# Access Compliance Report

## Public Rights-of-Way

### (Curb Ramps)

Intersection ID: N/A	Main Street: AGNEW_DR	Cross Street: COWGILL_LN	Location: NW
ADA ID: 64EEDFFC1E6A	Ramp Type: Perp	Initial Pass/Fail: Fail	Overall Compliance: No
Severity Score: 10			
Codes/Mitigation Info/Possible Solution		Field Measurements/Component Compliance

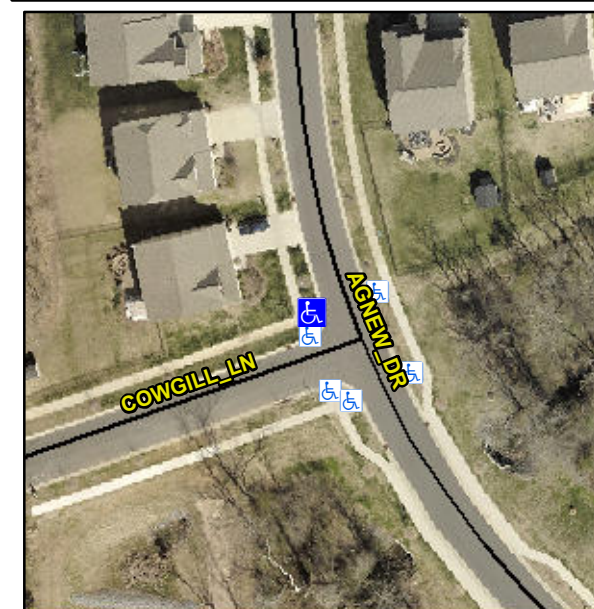
**Not Found, R304.5.1, R304.5.3**

Compliance	Description	Data	Compliance	Description	Data
N/A	Ramp Length (in)	99.0	Yes	Ramp Slope (%)	3.4
No	Ramp Width (in)	39.0	No	Ramp XSlope (%)	3.2
N/A	Flare Type LT	N/A	N/A	Flare Type RT	N/A
N/A	Flare Slope LT (%)	N/A	N/A	Flare Slope RT (%)	N/A
N/A	Flare Traversable LT?	N/A	N/A	Flare Traversable RT?	N/A
N/A	Landing Length (in)	N/A	N/A	DWS Provided?	N/A
N/A	Landing Width (in)	N/A	N/A	DWS Contrast?	N/A
N/A	Landing Slope (%)	N/A	N/A	DWS Length (in)	N/A
N/A	Landing X Slope (%)	N/A	N/A	DWS Full Width?	N/A
N/A	Landing Curb? (Y/N)	N/A	N/A	DWS Offset (in)	N/A
N/A	Shared Landing?	N/A			
N/A	Gutter Ponding?	N/A	N/A	Gutter Slope (%)	N/A
N/A	Gutter Lip Ht (in)	N/A	N/A	Gutter X Slope (%)	N/A
N/A	Painted X Walk1?	No	N/A	Painted X Walk2?	N/A
	X Walk 1 Direction	To NE		X Walk 2 Direction	N/A
N/A	X Walk 1 Width (in)	N/A	N/A	X Walk 2 Width (in)	N/A
	X Walk 1 Slope (%)	2.4		X Walk 2 Slope (%)	N/A
	X Walk 1 X Slope (%)	2.6		X Walk 2 X Slope (%)	N/A

**Remove & Replace Entire Ramp.**
